CALIFORNIA CROSSROADS

Stage 3 Road Safety Audit – GG119 Decision Log

PROJECT NO. UK-70104511

OUR REF. NO. UK-70104511/RSA3/1/0

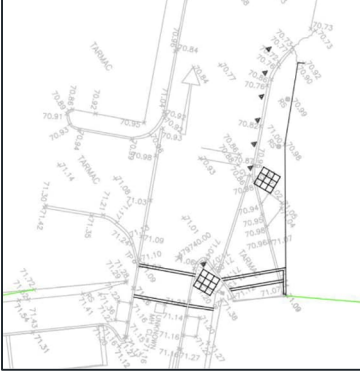
RSA2 problem	RSA Recommendation	Design Organisation Response	Overseeing Organisation Response	Agreed RSA action
<p>Problem 4</p> <p>Location: Pedestrian crossing facility across Nine Mile Ride, adjacent to the Pace petrol station – see Appendix B for location.</p> <p>Summary: Existing petrol station sign will restrict the visibility from the adjacent crossing point.</p> <p>On the corner of the junction adjacent to the petrol station, all of the existing traffic signs shown on the photograph below will be removed from this location, although the Pace petrol station sign will be retained. The existing street lighting column will be replaced with a new lighting column that will be installed on the right-hand side of the petrol station sign.</p> <p>A new pedestrian crossing point will be provided on this corner of the junction. The visibility from the crossing point of vehicles approaching from the south-west on Finchampstead Road will be restricted to approximately 10-12m by the petrol station sign and the new street lighting column.</p> <p>This could increase the possibility of a pedestrian crossing Nine Mile Ride in this location when a vehicle is turning left from Finchampstead Road onto Nine Mile Ride, leading to a collision.</p>	<p>As shown on the following photograph, it was observed that the petrol station fuel price totem restricts the visibility from the new pedestrian crossing point on the south side of the western nine Mile Ride junction approach (i.e. obstructing the visibility of vehicles that are about to turn left from Finchampstead Road onto Nine Mile Ride). Therefore, it is still recommended that the local highway authority consults with the petrol station owner to determine whether the petrol station sign can be relocated to a position where it will not restrict the visibility from the adjacent pedestrian crossing point (if this has not been done already). It is noted that the Design Team/ Overseeing Organisation have stated that the pedestrian crossing facility will remain in place, even if the petrol station sign cannot be moved.</p>	<p>Recommendation Rejected</p> <p>It is thought the totem on site now is not the one present when the visibility splay was measured. Please can WBC confirm a conversation was had with the petrol station owner and confirm its location, so we can assess if the splays are different to our original assessment. WSP to advise once the location is confirmed.</p>	<p>Agreed totem has changed since design was completed. WBC to arrange for contractor to confirm its location and highlight any changes from the original design. WSP can then complete a review of visibility splays and provide feedback.</p>	<p>WBC to survey location of totem and WSP to review visibility splay.</p>

PROBLEM LOCATION PLAN

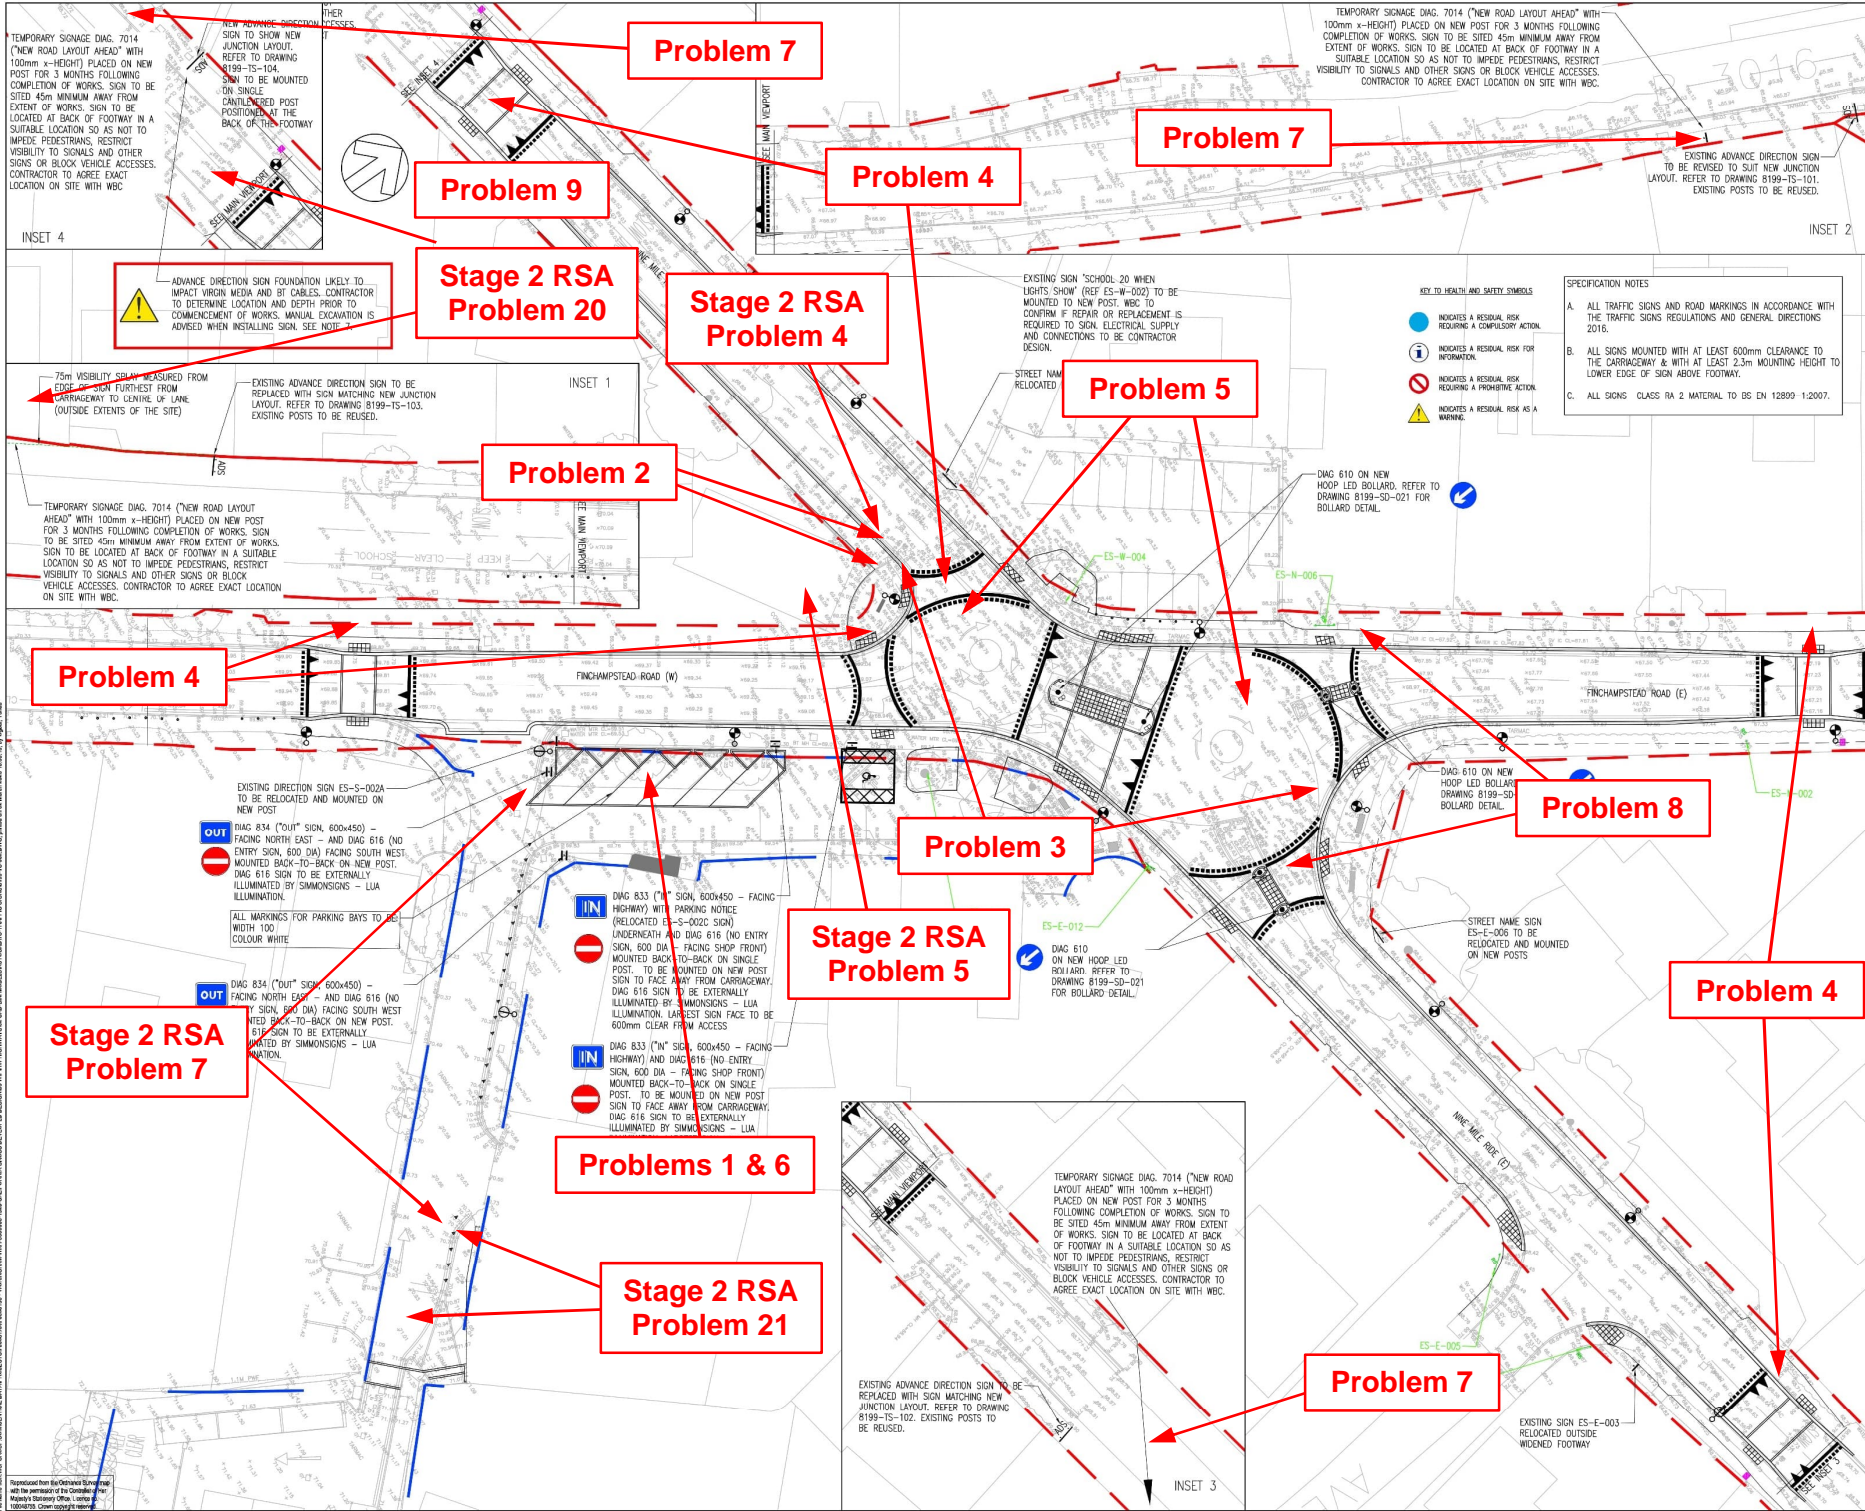
RSA3 problem	RSA Recommendation	Design Organisation Response	Overseeing Organisation Response	Agreed RSA action
<p>Problem 1</p> <p>Location: Parking area for the shops on the south side of the California Crossroads junction – see Appendix B for location.</p> <p>Summary: Removal of the footway could increase the possibility of conflicts between pedestrians and vehicles in the parking area.</p> <p>In the previous road layout in this location, there was a footway provided adjacent to the row of shops on the south side of the California Crossroads junction. This footway has been removed as part of the scheme. It was observed during the site visit that several pedestrians were walking through the centre of this area in locations where vehicles will be turning into or out of the echelon parking bays (as shown on the photograph below). Anecdotal comments from some members of the public suggested that the new layout has increased the possibility of conflicts between vehicles and pedestrians walking through the parking area.</p>	<p>It is recommended that appropriate 'virtual footway' road markings are provided at the back of the parking area (directly adjacent to the shops) in order to encourage pedestrians to travel through this area away from the locations where vehicles will be turning into or out of the parking bays.</p>	<p>Recommendation Rejected</p> <p>The design layout conforms with the guidelines within Manual for Streets, which states that shared use spaces are likely to work well</p> <ul style="list-style-type: none"> • In short lengths or where they form cul-de-sacs • Where motor vehicle traffic is below 1—vehicles per hour, and • Where parking is controlled or takes place in designated areas <p>WBC are considering commissioning WSP to film the operation of the crossings over a couple of days to assess their performance. WBC to confirm if this commission should be</p>	<p>Reject Auditors Recommendation and Accept Designer Responses:</p> <p>In the previous arrangement, pedestrians (in addition to those accessing their vehicles) would walk in the road, into areas where drivers were reversing out of parking spaces.</p> <p>As there wasn't enough room to expand the footpath, the new layout eliminates the delineated footpath. Consequently, drivers should now expect pedestrians in their path from time to time, fostering increased driver awareness of a situation that was happening informally before.</p> <p>Additionally, drivers are now required to reverse into the parking spaces, so they can drive out forwards, which</p>	<p>We are mindful of public feedback, so WSP will review video footage and gather observations before the RSA 4 is undertaken.</p>

RSA3 problem	RSA Recommendation	Design Organisation Response	Overseeing Organisation Response	Agreed RSA action
<p>Problem 2</p> <p>Location: South-western corner of the California Crossroads junction – see Appendix B for location.</p> <p>Summary: Petrol station signage could present an obstruction on the footway as well as further restricting the visibility to / from the adjacent pedestrian crossing points.</p> <p>As shown on the following photograph, there is a temporary petrol station sign and a ‘coffee cup’ feature positioned on the new footway on the south-western corner of the junction. During the site visit, it was observed that the adjacent petrol station fuel price totem restricts the visibility to / from the adjacent pedestrian crossing points (see Problem 4 in Section 2.3 of this report), and the temporary sign and ‘coffee cup’ feature could further restrict the inter-visibility at the crossing points.</p> <p>This could increase the possibility of a driver not clearly seeing a pedestrian waiting at one of the adjacent crossing points (particularly a child pedestrian or a wheelchair user), which could increase the possibility of a pedestrian crossing the carriageway when a vehicle is turning onto Nine Mile Ride (West) or Finchampstead Road (South), possibly leading to a collision.</p> <p>In addition, the temporary sign and ‘coffee cup’ feature could present an obstruction on the footway which could increase the possibility of a pedestrian tripping over one of these features (particularly a visually impaired pedestrian).</p>	<p>It is recommended that the temporary sign and ‘coffee cup’ feature are removed or relocated to an alternative appropriate location where they will not obstruct any footways or visibility sight lines.</p>	<p>Recommendation Accepted</p> <p>WBC to discuss with the fuel station owner to remove or relocate the temporary sign and coffee cup feature to increase visibility at the pedestrian crossing point.</p>	<p>WBC to discuss location of the features with petrol station owner. Features will be requested to be moved back to sit closer to the kerb line of the station forecourt.</p>	<p>WBC to instruct the petrol station owner that the features are moved to the back of the footway before the RSA 4 is undertaken.</p>

RSA3 problem	RSA Recommendation	Design Organisation Response	Overseeing Organisation Response	Agreed RSA action
<p>Problem 3</p> <p>Location: South-western and north-eastern corners of the California Crossroads junction – see Appendix B for locations.</p> <p>Summary: Vehicles observed overrunning the footways when turning left onto Nine Mile Ride (West) and Nine Mile Ride (East).</p> <p>It was observed during the site visit that occasionally vehicles were overrunning the footways on the south-western and north-eastern corners of the junction, when undertaking the left-turn movements onto Nine Mile Ride (West) and Nine Mile Ride (East). This could increase the possibility of a vehicle colliding with a pedestrian on the footway.</p>	<p>It is recommended that this problem is specifically monitored during the initial months after opening to ascertain how regularly vehicles overrun the footways in these locations. This could be undertaken by utilising the CCTV equipment at the junction. If it is concluded that vehicles are periodically overrunning these footways, it is recommended that appropriate mitigation measures are installed (such as the provision of reflective bollards on the footway, adjacent to the kerblines).</p> <p>It is also recommended that a Stage 4 monitoring Road Safety Audit is completed for this scheme (when 12 months of personal injury collision data becomes available) in order to review how the new junction layout is operating in relation to this issue.</p>	<p>Recommendation Accepted</p> <p>WBC are considering commissioning WSP to film the operation of the crossings over a couple of days to assess their performance. WBC to confirm if this commission should be extended to assess the operation of this area.</p>	<p>Accepted. WBC have approved commission to assess crossing performance. The findings will be discussed and reviewed within RSA 4.</p>	<p>WSP to review video footage and feedback observations before RSA 4 is undertaken.</p>

RSA3 problem	RSA Recommendation	Design Organisation Response	Overseeing Organisation Response	Agreed RSA action
<p>Problem 4</p> <p>Location: Various new 'courtesy crossing' facilities – see Appendix B for locations.</p> <p>Summary: Possibility of a pedestrian crossing the carriageway when a vehicle has stopped on one approach to the crossing facility, and then being struck by another vehicle travelling in the opposite direction.</p> <p>Various new pedestrian crossing facilities have been provided throughout the extents of the scheme with road markings (similar to dashed 'give way' markings) provided on the carriageway either side of each crossing. During the site visit, it was observed that most vehicles stopped to give way to waiting pedestrians at these 'courtesy crossing' layouts, although some motorists did not stop when a pedestrian was waiting to cross the road.</p> <p>Due to the ambiguity of priorities at these crossings, potentially a pedestrian could see a vehicle stopping as it approaches from the right and then start walking across the carriageway. However, the pedestrian may not look to the left to check whether any other vehicles approaching in the opposite direction have also stopped to let them cross the carriageway. Therefore, this could result in the pedestrian being struck by a vehicle approaching from the left. This could be a particular problem at the new 'courtesy crossing' facilities with no pedestrian refuge islands in the centre of the carriageway, where pedestrians can cross the carriageway in two movements by waiting on the island.</p>	<p>It is recommended that appropriate "Look Both Ways" road markings are provided on the carriageway or on the footways adjacent to the crossing points, at the new 'courtesy crossing' facilities without any pedestrian refuge islands in the centre of the carriageway.</p>	<p>Recommendation Rejected</p> <p>We can assess the available space for the markings; however, it could give the false impression that drivers have priority over pedestrians.</p> <p>It is advised the crossings are monitored further, to understand if pedestrians are looking in both directions and the level of courtesy drivers are providing.</p>	<p>Reject Audit Response and Accept designer response:</p> <p>Accept designer response that inclusion of recommended wording could provide a false driver impression regarding priorities, and findings from crossing survey report that has been commissioned will be reviewed and considered in line with RSA4.</p>	<p>WSP and WBC to review available video footage and feedback observations before RSA 4 is undertaken.</p>

RSA3 problem	RSA Recommendation	Design Organisation Response	Overseeing Organisation Response	Agreed RSA action
<p>Problem 6</p> <p>Location: Parking area for the shops on the south side of the California Crossroads junction – see Appendix B for location.</p> <p>Summary: Vehicles driving through the parking area the wrong way could come into conflict with other vehicles and pedestrians.</p> <p>The layout for the parking area at the shops on the south side of California Crossroads has been changed, with the provision of ‘No Entry’, ‘In’ and ‘Out’ traffic signs to highlight to drivers that they should travel southbound through this area (whereas previously you could only travel northbound through the parking area).</p> <p>During the site visit, several vehicles were observed to be entering this area from the Avery Corner car park access road, contravening the ‘No Entry’ traffic signs, and travelling the wrong way through the parking area and sometimes resulting in the road user driving into a parking space and then having to reverse into the shared space area when they leave. This could increase the possibility of a conflict with another vehicle travelling through this area in the correct direction, or it could increase the potential for a conflict with a pedestrian walking through this area when a vehicle is reversing out of a parking space (see also Problem 1).</p>	<p>It is recommended that the new ‘No Entry’, ‘In’ and ‘Out’ traffic signs at both ends of the parking area are supplemented with appropriate arrow road markings to further highlight the correct direction that road users should be travelling through this area.</p>	<p>Recommendation Accepted</p> <p>Arrow Road markings to be supplemented at the ‘No Entry’, ‘In’ and ‘Out’ traffic signs to highlight the new one-way traffic layout.</p>	<p>These arrows have been installed</p>	<p>No further action is required.</p>

RSA3 problem	RSA Recommendation	Design Organisation Response	Overseeing Organisation Response	Agreed RSA action
<p>Problem 7</p> <p>Locations: Nine Mile Ride (West) / Nine Mile Ride (East) / Finchampstead Road (North) approaches to the junction – see Appendix B for locations.</p> <p>Summary: Adjacent vegetation restricts the visibility of the “New Road Layout Ahead” traffic signs.</p> <p>It was observed during the site visit that adjacent vegetation was restricting the forward visibility of the “New Road Layout Ahead” traffic signs on the Nine Mile Ride (West), Nine Mile Ride (East) and Finchampstead Road (North) approaches to the junction. This could reduce road users’ awareness that the junction layout ahead has been changed, which could increase the possibility of a vehicle approaching the junction at an inappropriate speed and entering the junction without giving way to other vehicles (resulting in a collision).</p>	<p>It is recommended that the vegetation located adjacent to the “New Road Layout Ahead” traffic signs is cut back appropriately so that these signs are clearly visible to road users.</p>	<p>Recommendation Accepted</p> <p>Vegetation to be trimmed back and recorded in the management plan and risk register.</p>	<p>WBC can confirm vegetation highlighted has already been cut back, and notes provided to maintenance teams highlighting the requirement for regular inspections.</p>	<p>No further action is required.</p>

RSA3 problem	RSA Recommendation	Design Organisation Response	Overseeing Organisation Response	Agreed RSA action
<p>Problem 8</p> <p>Locations: Nine Mile Ride (East) and Finchampstead Road (North) approaches to the junction – see Appendix B for locations.</p> <p>Summary: Lack of any road markings adjacent to the pedestrian refuge islands could increase the possibility of a vehicle colliding with the island.</p> <p>On the Nine Mile Ride (East) and Finchampstead Road (North) approaches to the junction, ‘courtesy crossing’ facilities have been provided with pedestrian refuge islands in the centre of the crossings, as shown on the photograph below. No road markings have been provided in the centre of the carriageway to highlight the presence of the islands to road users, which may increase the potential of a road user mistakenly travelling too close to an island and colliding into it.</p> 	<p>It is recommended that appropriate hatched road markings, with a short length of longitudinal warning line road markings, are provided directly adjacent the refuge islands in these locations.</p>	<p>Recommendation Rejected</p> <p>The addition of hatched road markings from the refuge island could detract from the scheme approach. Traffic sign 610 should suffice.</p>	<p>Agree with designer response.</p>	<p>No further Action required.</p>

RSA3 problem	RSA Recommendation	Design Organisation Response	Overseeing Organisation Response	Agreed RSA action
<p>Problem 9:</p> <p>Location: Nine Mile Ride approximately 70m to the west of California Crossroads – see Appendix B for location.</p> <p>Summary: Dark area next to the new raised table crossing facility.</p> <p>As shown on the following photograph, it was observed during the darkness site inspection that vegetation located adjacent to a new street lighting column was creating a dark area next to the new raised table crossing facility, located on Nine Mile Ride to the west of California Crossroads. This could increase the possibility of a road user’s eyes not adjusting adequately to the change in illumination, which may lead to them not clearly seeing a pedestrian about to cross the carriageway at the ‘courtesy crossing’ facility (possibly resulting in a collision).</p> <p>In addition, if a pedestrian chooses to cross the road away from the location of the crossing facility (i.e. in the dark area of the carriageway), a motorist may not clearly see the pedestrian crossing the road ahead, leading to a collision.</p>	<p>It is recommended that the vegetation located adjacent to the street lighting column is cut back appropriately (with an allowance for seasonal growth) in order to provide adequate illumination of the carriageway in this location.</p> 	<p>Recommendation Accepted</p> <p>Vegetation to be trimmed back and recorded in the management plan and risk register.</p>	<p>WBC can confirm vegetation has been cut back at this location.</p>	<p>No Further Action Required.</p>
